TAL-CO SUPPLEMENTAL INSTRUCTION #03			
Project Name:	RW TOMLINSON - NEW HEAD OFFICE		
Project Location:	100 Nortel Drive, Ottawa, Ontario		
ARCH. SI #:	N/A	Issued By:	Chris Simpson
STRUC. SI #:	SSI #3	Date Issued:	September 23, 2016
MECH. SI #:	N/A	Revision #:	N/A
ELEC. SI #:	N/A	Revision Date:	N/A

**Title:** Structural Reinforcing for Architectural Feature walls at building entrances.

# STRUCTURAL SITE INSTRUCTION

**STRUCTURAL SITE INSTRUCTION No.:** 003

**SSI-S3  
SK1**

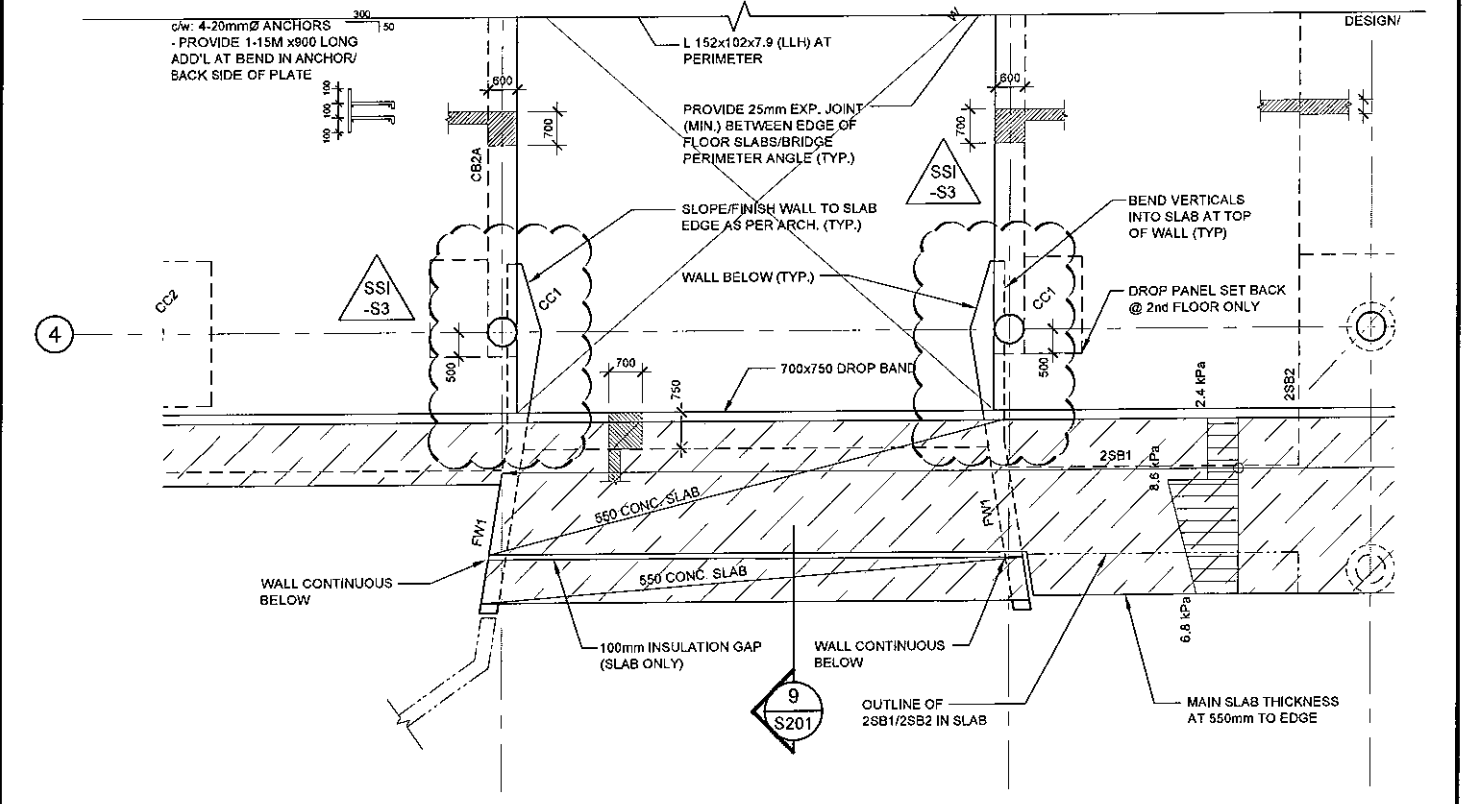
Updated the wall reinforcing and concrete extents of the FW1 walls as per the attached sketches SSI-S3-SK1 & SK2.
